HOWELL TOWNSHIP PLANNING COMMISSION REGULAR MEETING 3525 Byron Road

Site Plan Review For Howell Township, Michigan

Applicant:	Old Glory LLC
Project Name:	Parking Lot Addition
Plan Date:	January 25, 2024
Location:	4120 W Grand River Ave
Zoning:	Regional Service Commercial District (RSC)
Action Requested:	Preliminary Site Plan Approval

RE: Old Glory Car Wash 4120 Grand River Avenue, Howell Township Preliminary Site Plan Review

& ENGIN	A LAN W. PRUSS NGINEER Sooooooooooooooooooooooooooooooooooo
OLD GL FOWLER POC:	NEW TOUCHLESS WASH BAKS NIE VIETA SHOMM SUBJECT AND
DATE 1/25/2024	HOWELL
PLAN SUBMITTALS/REVISIONS SITE PLAN SUBMITTAL	
ORIGINAL	. ISSUE DATE:
	T NO: 22-177
SCALE:	
Ó FIELD: DRAWN E DESIGN E CHECK E	BY:
C	D-1.0

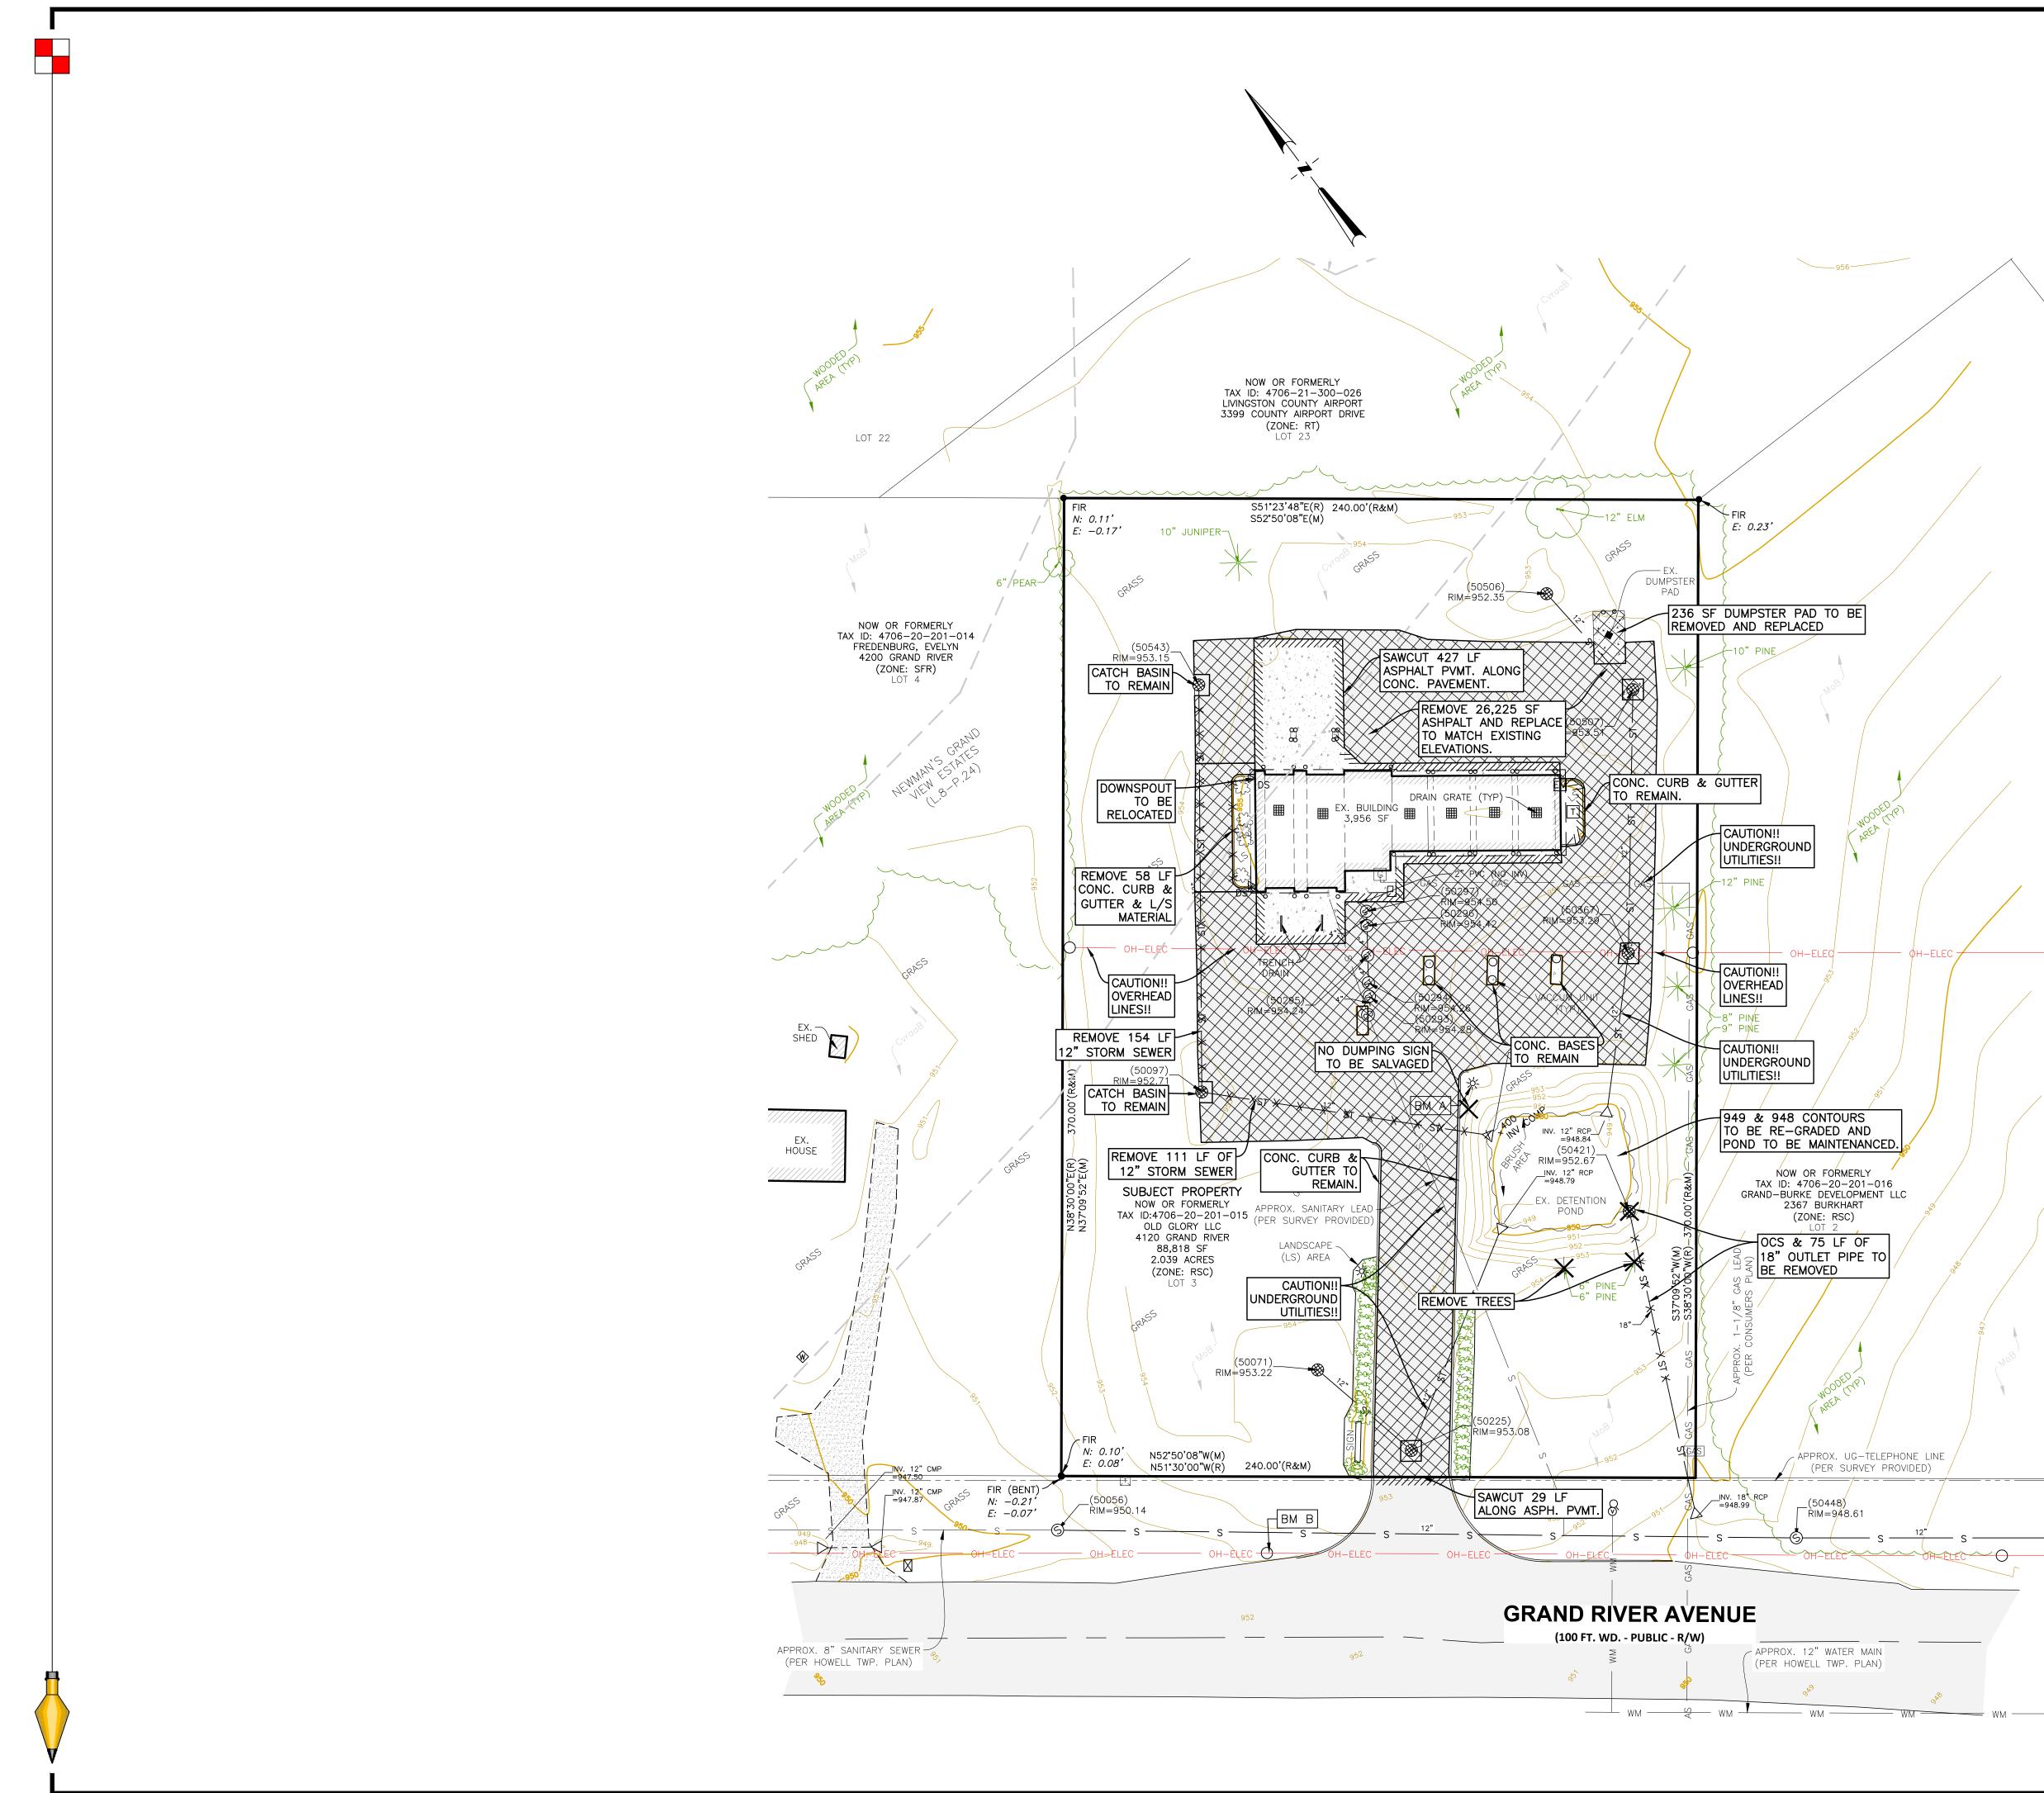
On sheet CD-1.0 two (2) existing pine trees are said to be removed. On sheet LS24.004.02 the same two (2) pine trees are listed as existing to remain and are counted towards landscaping requirements for the detention area. The above table reflects the count of the existing trees remaining. It should be clarified if the pine trees will remain or be removed with an updated count to reflect this. The "existing" number of shrubs should be clarified to show compliance with the ordinance following the expansion of the detention pond.

- 4. Demonstrate adequate parking for the site as defined in Section 18.02.G.5 for Gasoline Filling and Service Stations.
- 5. The number of existing shrubs surrounding the detention pond should be clarified.
- 6. The two (2) pine trees currently counted toward the stormwater detention pond should be clarified if they are to remain or be removed.
- 7. The applicant shall provide light fixture details and a photometric plan that demonstrates compliance with Section 14.22.
- 8. The trash enclosure screening should be included in the plans with the height and material listed.

C-1.0

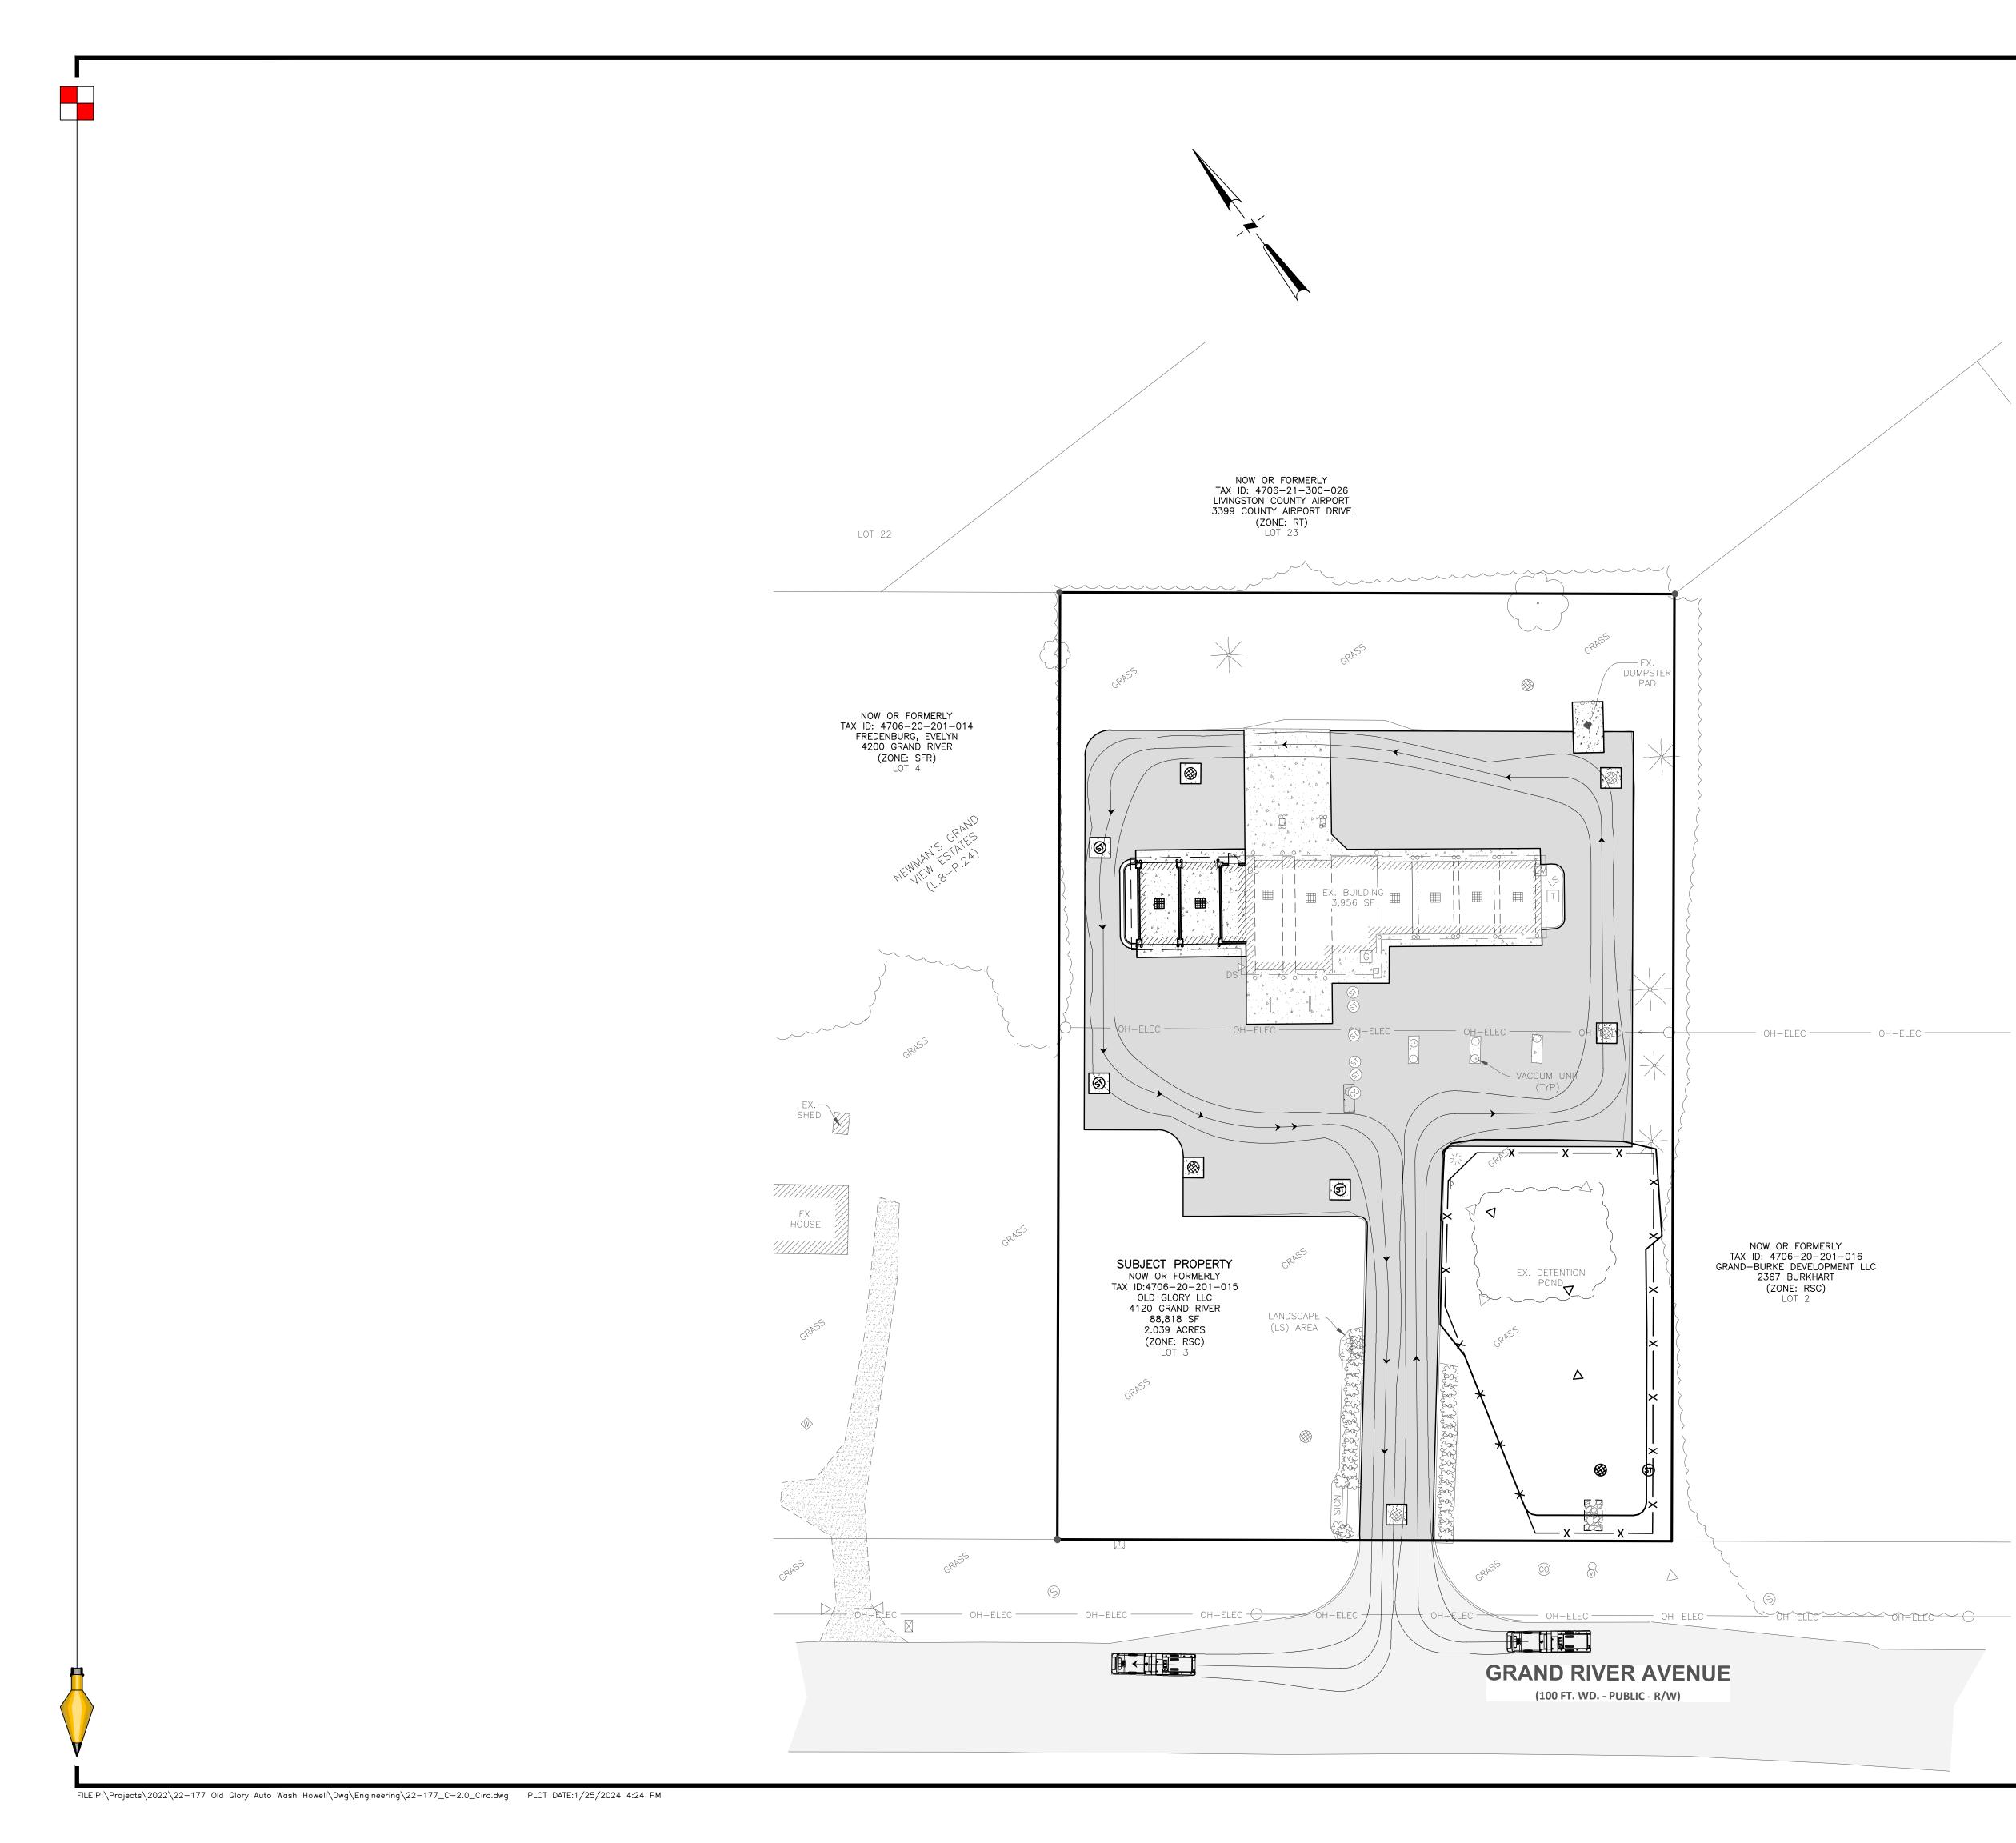
The setback standards listed on the site plan appear to alter slightly throughout and should be clarified to reflect the proposed extension of the detention pond. The proposed extension of the detention pond does not meet ordinance setbacks in both the front and side yards. The building height is not included on Sheet C.1.0 in the table Zoning Information, but is listed as 8ft in later elevation sheets.

Items to be Addressed: 1) The height of the proposed building should be clarified on Sheet C.1.0. 2) The applicant will need to revise plans or apply for a variance to approve the proposed structure setbacks of the detention pond.

- 1. The applicant shall request a variance to approve the proposed structure setbacks of the detention pond or revise plans to meet the Ordinance requirements.
- 2. The height of the proposed building should be listed on Sheet C.1.0.
- 3. List the number of employees at maximum employment.
